STAFF REPORT

Date: April 4, 2024

Subject: Eric Wright and Jessie McKay, Single Family Dwelling Addition/Modification
490 Tuscarora Rd., Crystal Bay, Washoe County, Nevada
Assessor's Parcel Number 123-121-11, TRPA File Number ERSP2023-1731

1 TRPA COVERAGE PLAN P1
 1" = 10'-0"

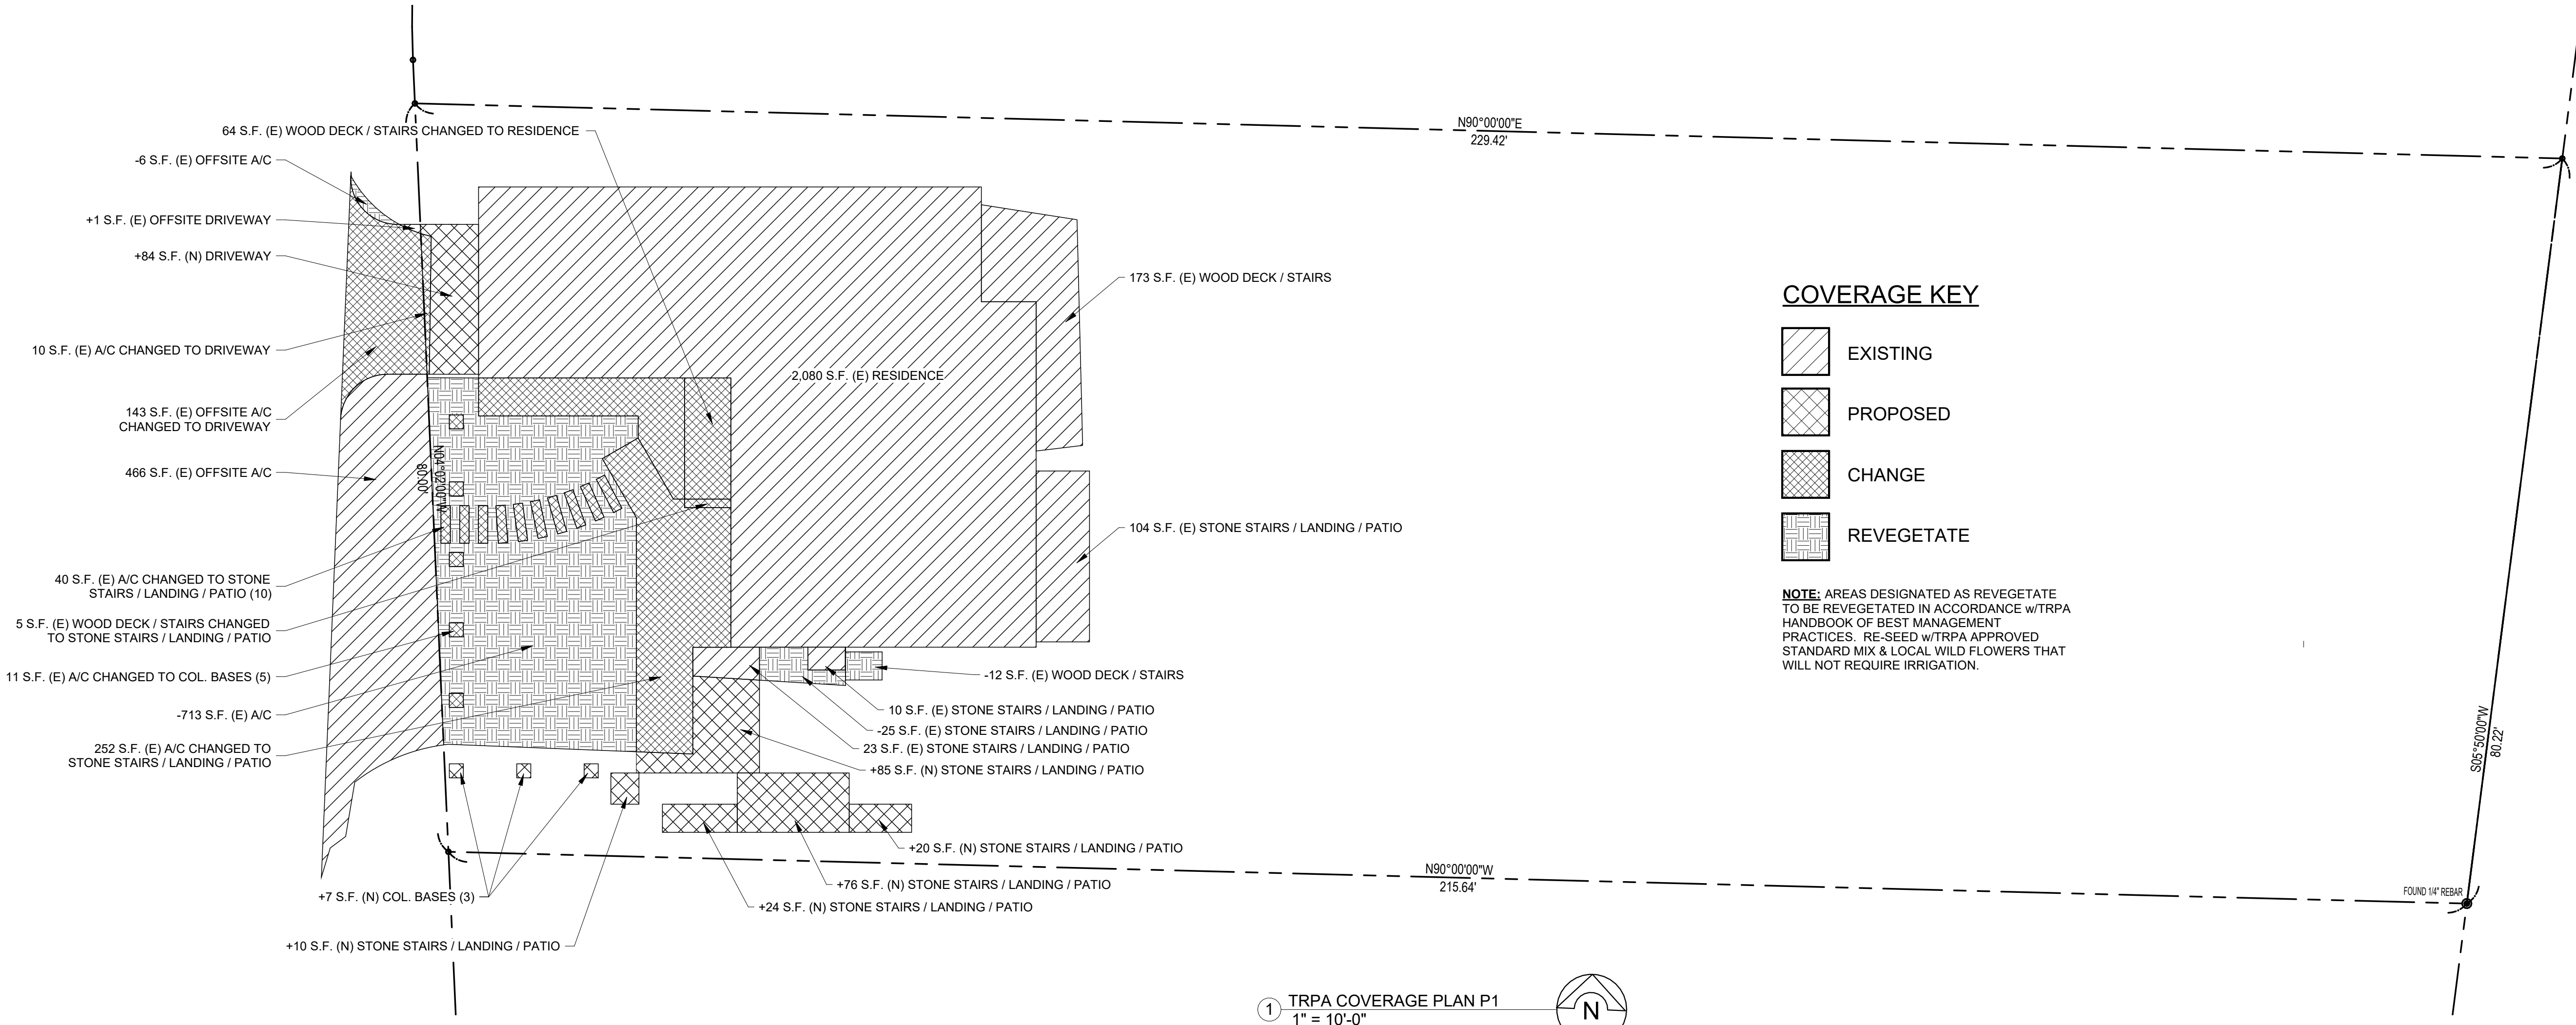
- (1) The detail of the Coverage Table on Sheet SP-2 is confusing. Please update the coverage table with the information as it is presented in the sample land coverage table below.

- (2) Include identification of the excess coverage amount and previously mitigated excess coverage on Sheet SP-2:
